Subject: GHG “Deemed to Comply” Regulatory Changes and Minor Revisions to LEV III

I am writing on behalf of the Alliance of Automobile Manufacturers (Alliance), a trade association of 12 car and light-truck manufacturers representing over 75 percent of the new vehicle market. The Alliance supports changes to harmonize the federal and California GHG regulations as well as the minor revisions to LEV III. This letter contains recommendations that either streamline the harmonization of GHG regulations, or improve the LEV III criteria emission regulations by reducing costs and testing burden without impacting the environmental benefits of the LEV III program.

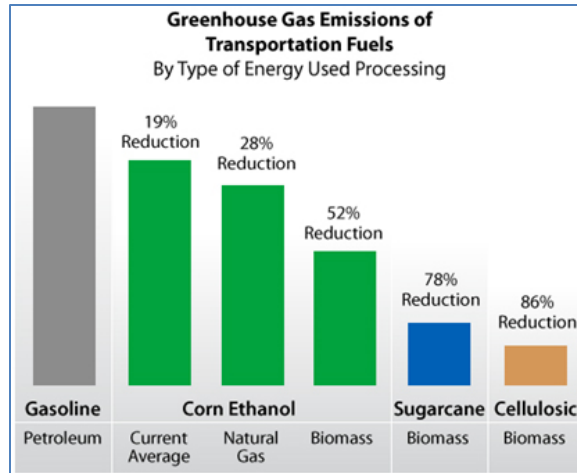
A review of the average temperatures in California's major ozone non-attainment areas (e.g., Los Angeles, Sacramento, Fresno, and San Diego) shows that the average lows are well above 50°F during the summer ozone season (Jun-Sep) (see below). Thus, these vehicles are unlikely to experience a start at 50°F during the time when criteria emissions are most important.

In truth, of the 20+ million vehicles in California, there are probably fewer than 12 vehicles each day that are started when the temperature is 50°F and the tank contains 85% ethanol (i.e., E85). Even those starts are probably not occurring on a high-ozone day. Nonetheless, every flexible fuel vehicle (FFV) is required to certify at 50°F using E85. This results in not only unnecessary testing, but also unnecessary emission control hardware on every FFV at a cost of millions of dollars annually.

Since the number of FFVs that will be started using E85 at 50°F will be infinitesimally small, given the current number of fuel stations in California, we recommend eliminating the 50°F test on E85 until ARB determines that E85 accounts for at least 10% of the total gasoline plus E85 sold in California for a consecutive 12 month period, i.e.:

This threshold would indicate that E85 is being used in sufficient quantity to justify the additional testing and hardware required. Manufacturers would be required to comply with the 50°F testing requirements starting one full model year after the 10% trigger is reached.
